# SAN FRANCISCO PLANNING DEPARTMENT

## Discretionary Review Full Analysis

*Date:* August 31, 2011  
*Case No.:* 2010.0479DD  
*Project Address:* 1456 Chestnut Street  
*Permit Application:* 2010.06.16.4608  
*Zoning:* RH-3 (Residential House, Three-Family)  
40-X Height and Bulk District  
*Block/Lot:* 0480/003E  
*Project Sponsor:* John Schlesinger, A.I.A.  
351 Valley Street  
San Francisco, CA 94131  
*Staff Contact:* Aaron Starr – (415) 558-6362  
[Aaron.Starr@sfgov.org](mailto:Aaron.Starr@sfgov.org)  
*Recommendation:* **Take DR and Approve the Project with Modifications**

A0.1.A

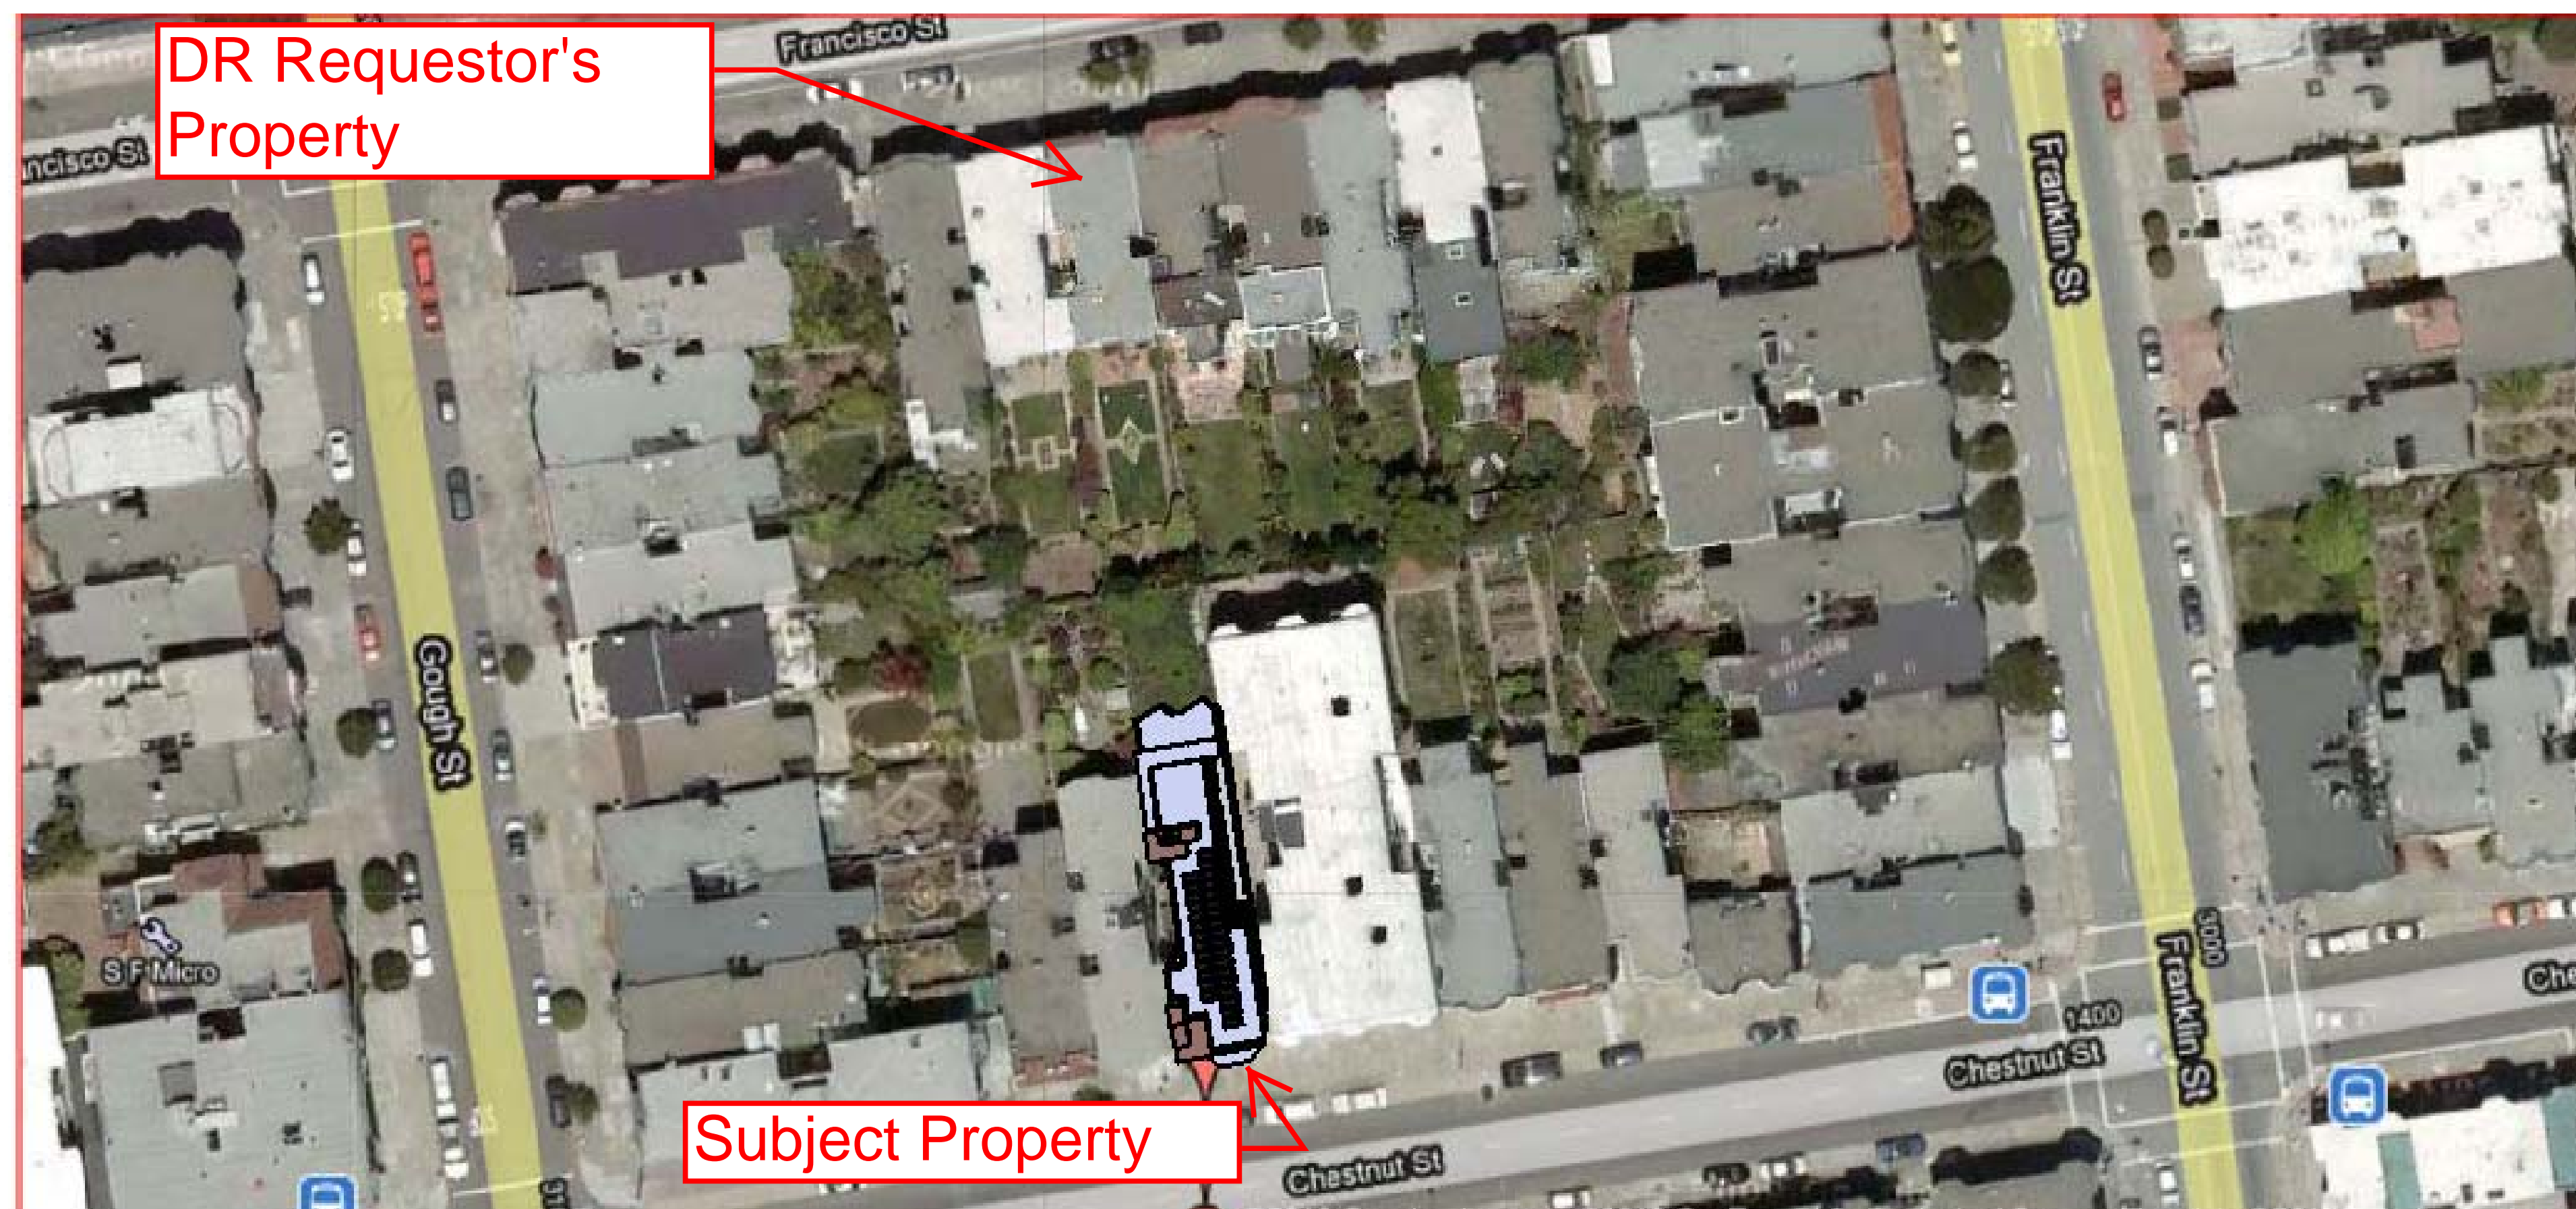
rear yard open spaces that are pinched mid block by the large 4 story multi-unit building to the East of the subject property (**See sheets A0.1.A-A0.1.D**).
